Re: **Wolf Farm Soccer Fields
Conditional Use
SMT Plan No. 20230017**

MEMORANDUM

RE: #20230017 - WOLF FARM SOCCER FIELD

PLAN TYPE: Conditional Use

Turning Performance Analysis

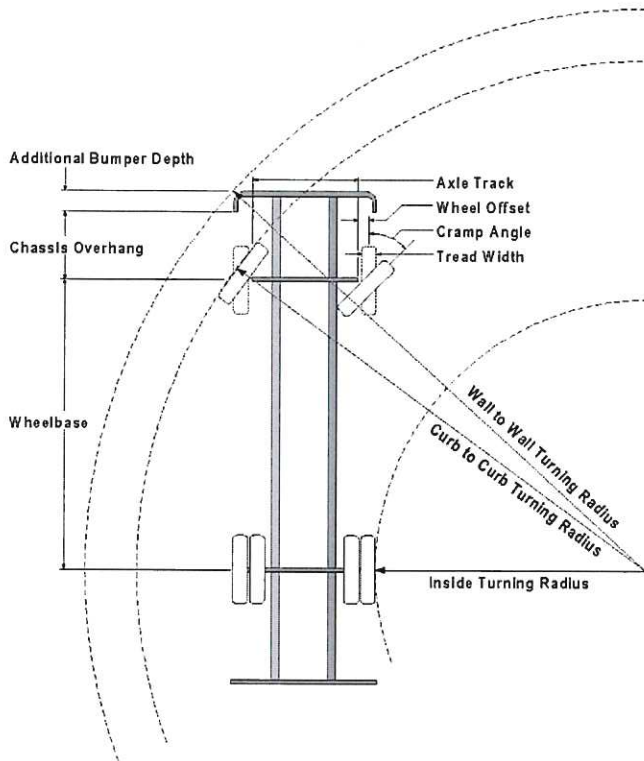
1. Secondary emergency access road is required. IFC 503.1.2
2. Roads shall be designed with enough clearance to safely maneuver first due Truck throughout complex. Please refer to Fire Apparatus dimensions' sheet and Turning performance analysis sheets included with these comments. IFC 503.2.
